Application for Licence Amendment

Part V Division 3 of the *Environmental Protection Act 1986*

Licence Number	L9056/2017/1
Licence Holder	Pilgangoora Operations Pty Ltd
ACN	616 560 395
File Number	DER2017/000318-1
Premises	<p>Pilgangoora Lithium – Tantalum Project</p> <p>Mining tenements M45/1256, M45/511, M45/333, L45/417, L45/454, L45/614, G45/350, G45/351</p> <p>MARBLE BAR WA 6760</p> <p>As defined by the premises maps attached to the revised licence</p>
Date of Report	27 May 2025
Decision	Revised licence granted

Figure 1 Revised prescribed premises boundary (outlined in yellow)

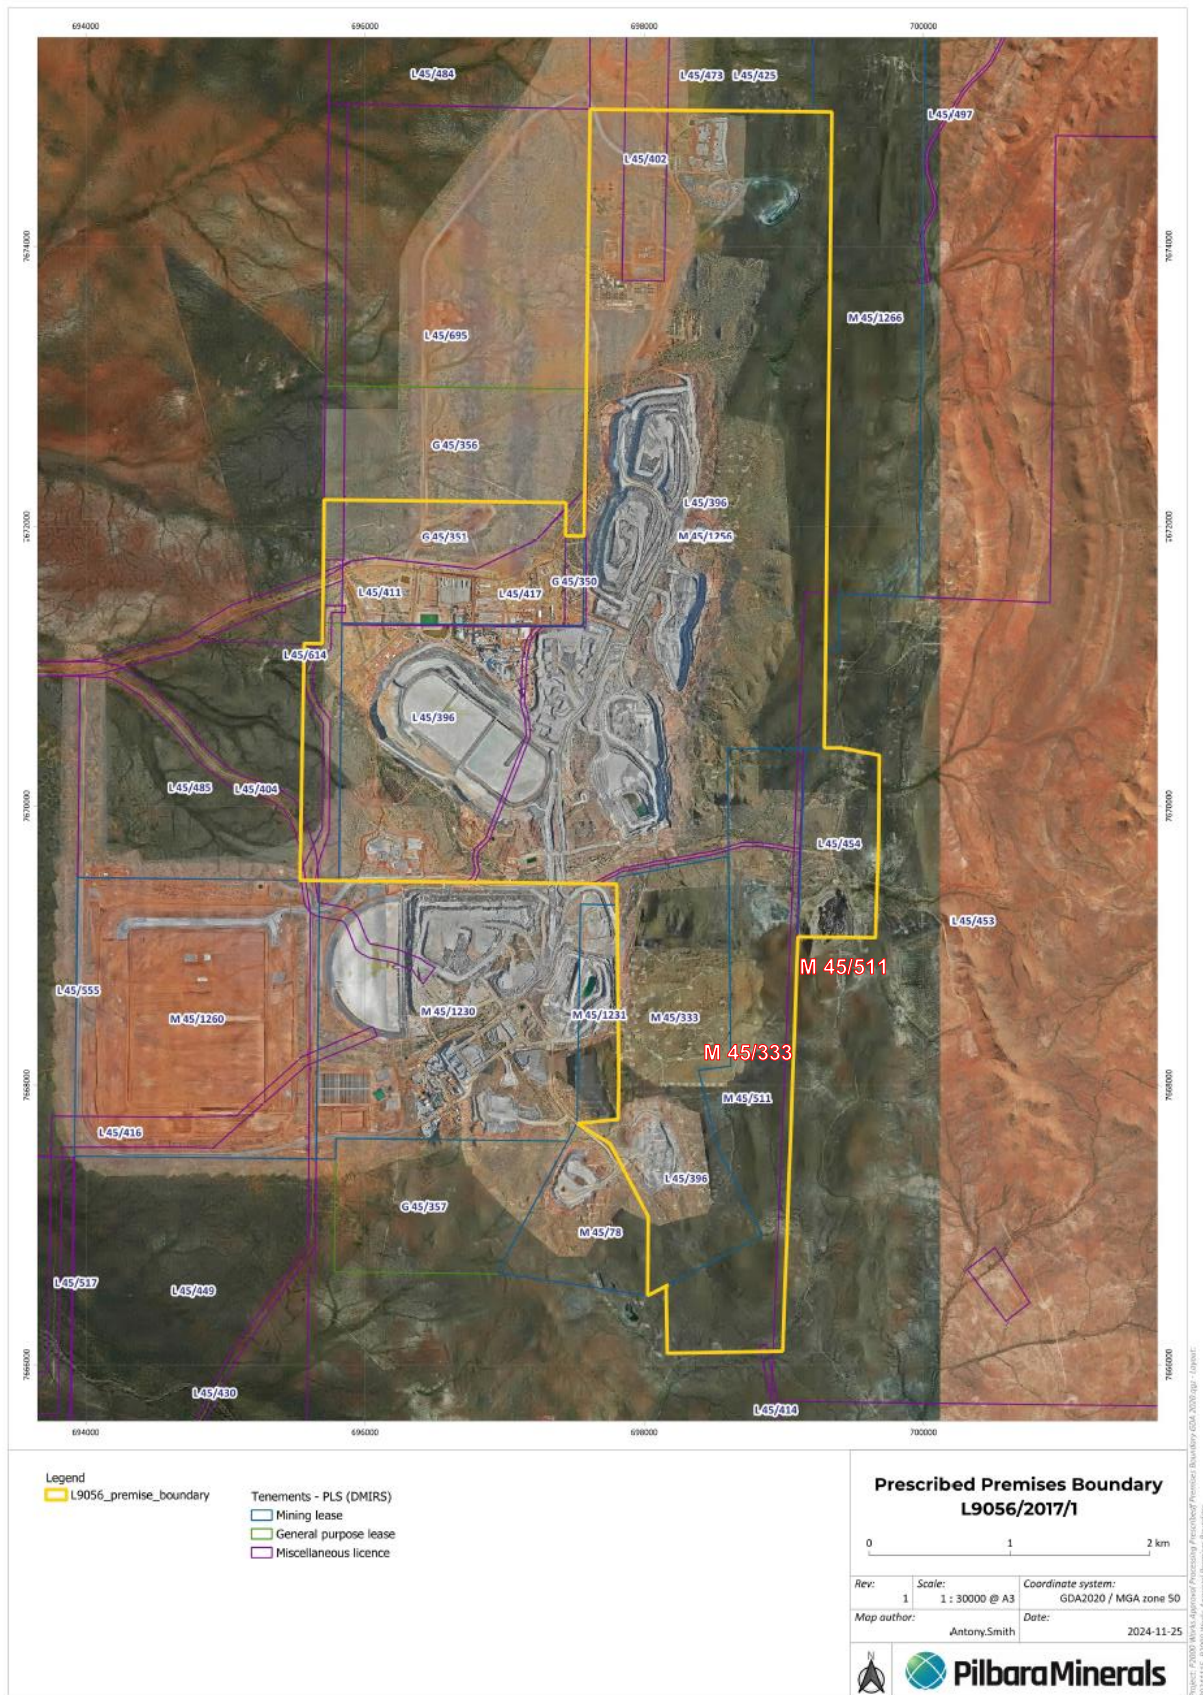
The licence holder has requested that the licence boundary for L9056/2017/1 incorporates the areas outlined in works approvals W6051/2017/1, W6766/2022/1, and W6443/2020/1.

Figure 2: Dewatering discharge point relocation

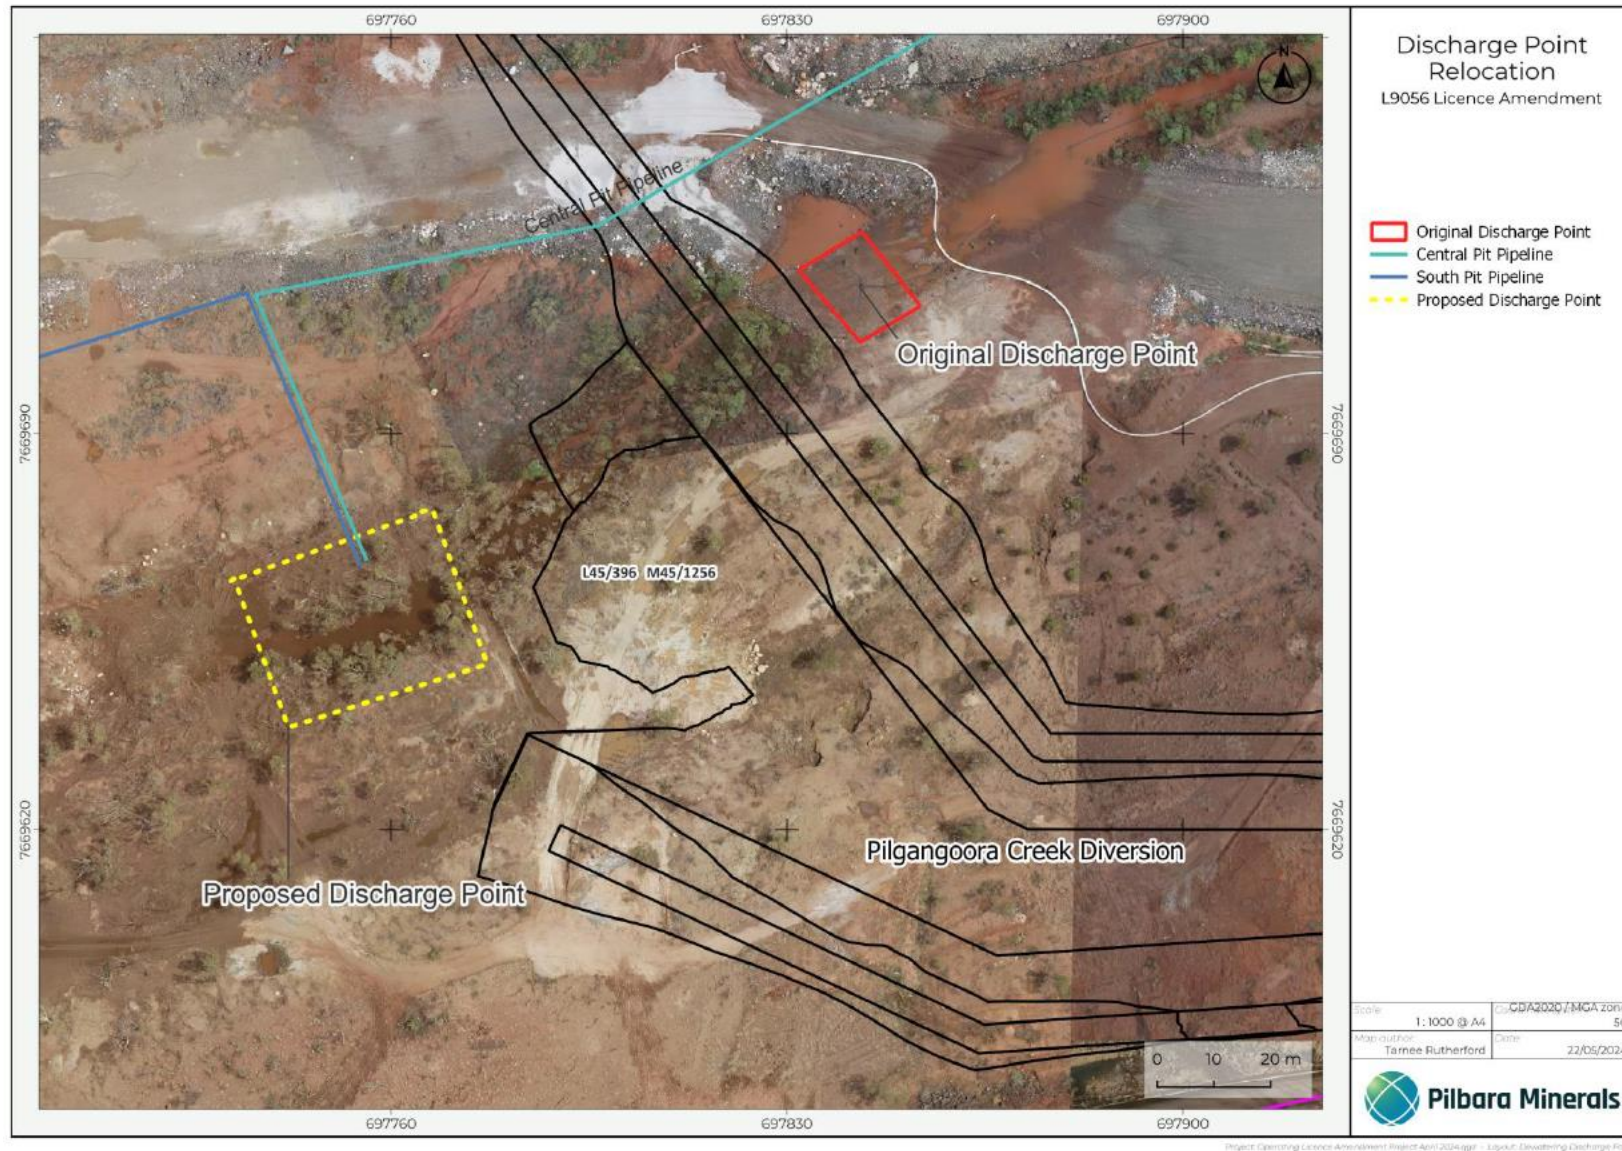
- Move the discharge point authorised under W6443/2020/1 100 metres to the west of Pilgangoora Creek (Figure 2) and construction of the associated additional pipeline. The licence holder has indicated that they would use the same controls and conditions in works approval W6443/2020/1 for the changes to the discharge point and pipeline.

- Construct a dewatering pipeline from an off-site operation (owned by the same operator) to facilitate dewatering from an adjacent premises (south pit under L9036/2017/1), that will discharge to the same point at Pilgangoora Creek (Figure 3). The adjacent premises is the Ngungaju Lithium Operations (NLO), operated under Part V licence L9036/2017/1 and held by Pilgangoora Operations Pty Ltd.

- **water quality should be sampled at the discharge point and up and down stream of Pilgangoora Creek to confirm nitrate levels remain under ANZECC livestock guidelines, ensuring downstream systems are not impacted post any discharge event;**
- **applicant controls for sampling, trigger levels and management actions are conditioned to manage the risk of impact on downstream ecosystems and livestock use; and**
- **the requested increase in flow rate does not increase the risk with current controls in the licence including the total annual volume. This will allow a faster discharge in case of excessive rainfall.**

Figure 4: Wastewater treatment plants and spray fields

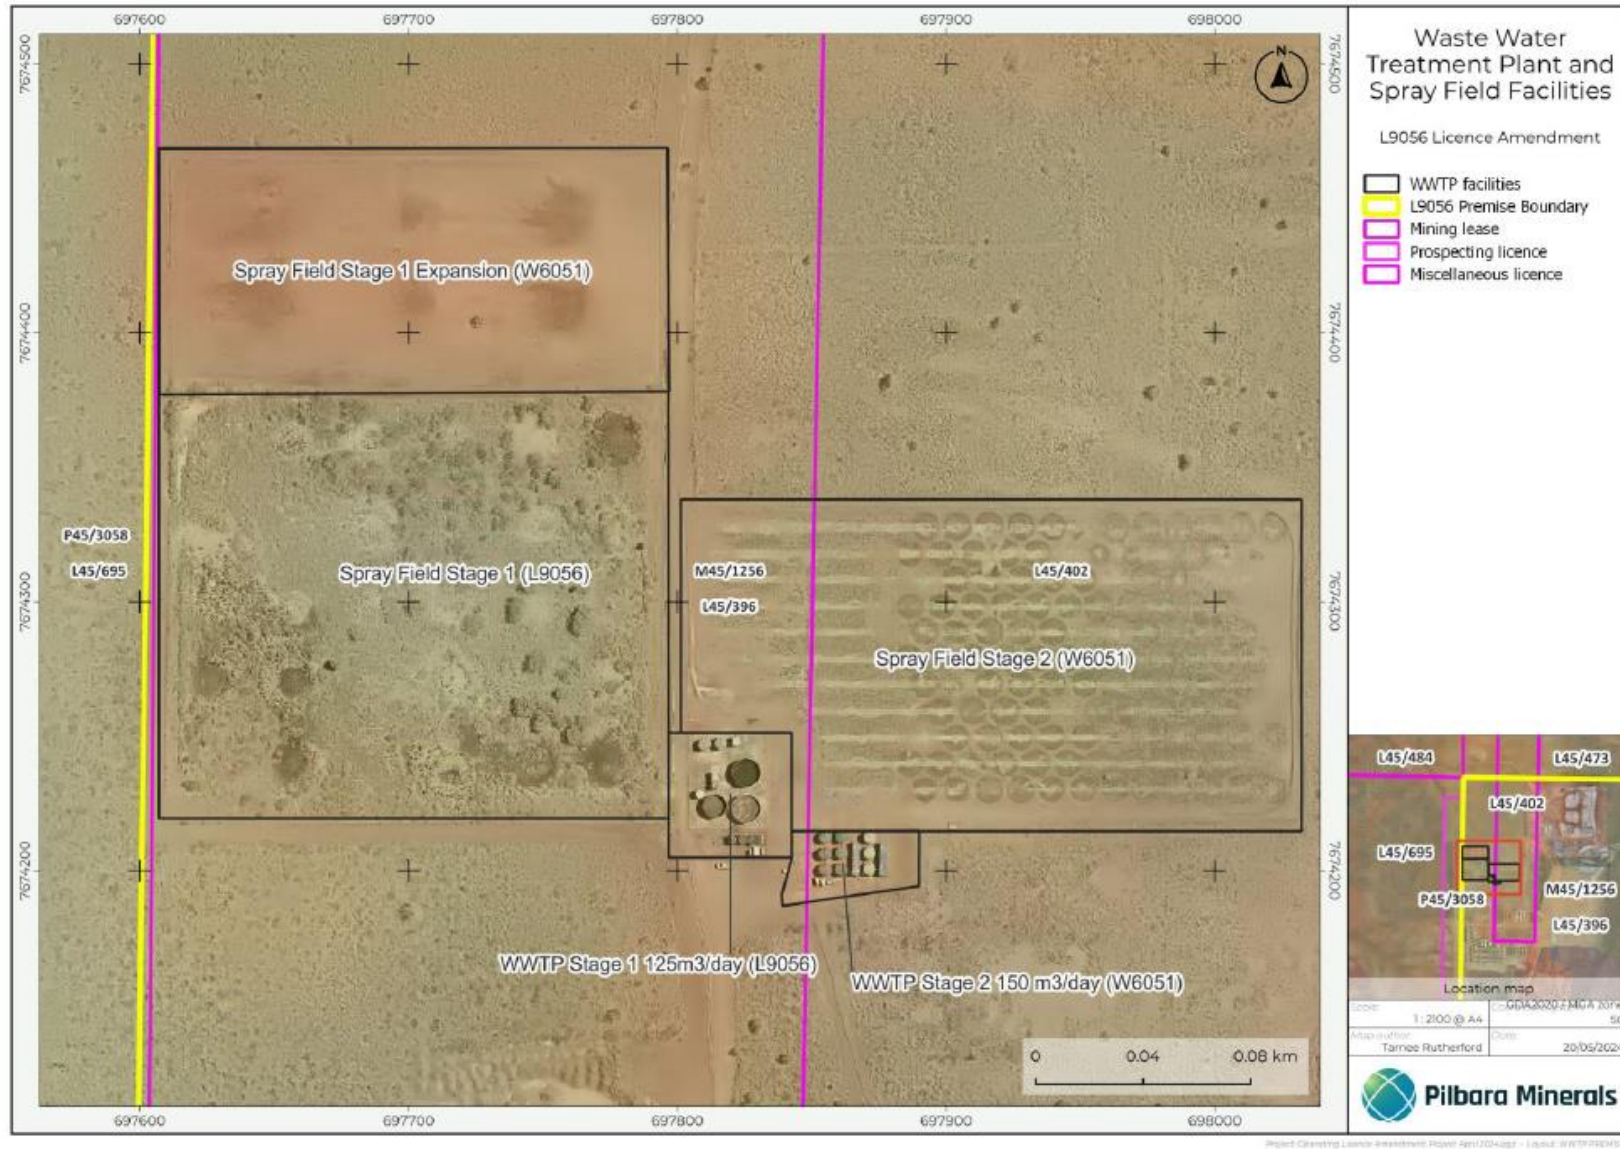
- stage one: 1.69 hectares with 18 sprinklers (built as 6 larger sprinkler heads); and
- stage two: 2.63 hectares with 26 sprinklers (Figure 4),

as constructed under works approval W6051/2017/1. The additional infrastructure will support the increase to the licensed category 54 capacity from 150 m³ to 275 m³ per day, and irrigation fields from the existing 3.04 to 7.36 hectares (3.04 + 1.69 + 2.63).

No nutrient loading calculations were provided by the applicant.

Based on the applicant's WWTP water quality emission criteria for total nitrogen (30 mg/L), total phosphorus (7.5 mg/L), the proposed 7.36 hectares of irrigation to land and daily WWTP capacity of 275 m³ (kL). The following nutrient loads have been calculated.

- Total nitrogen 8.25 kg/day (3,011.25 kg/year)
- Total phosphorus 2.06 kg/day (752.81 kg/year)

The irrigation area consists of arid native vegetation that is unlikely to uptake and utilise the nitrogen and phosphorus. The rates of irrigation in the long term are likely to contaminate soil through the accumulation of nutrients within the topsoil. It is unlikely that nutrients applied would leach below the ground as the evaporation rates are high throughout the year. An existing soil berm exists around the irrigation areas to prevent surface water runoff from storm events. The existing licence conditions requires vegetation health to not decline, and that healthy vegetation is maintained over the irrigation areas. The delegated officer has considered these existing conditions suitable.

The delegated officer advises that future wastewater disposal practices should consider evaporation ponds as an appropriate alternative wastewater disposal method for high evaporation areas over irrigation to land to prevent soil contamination.
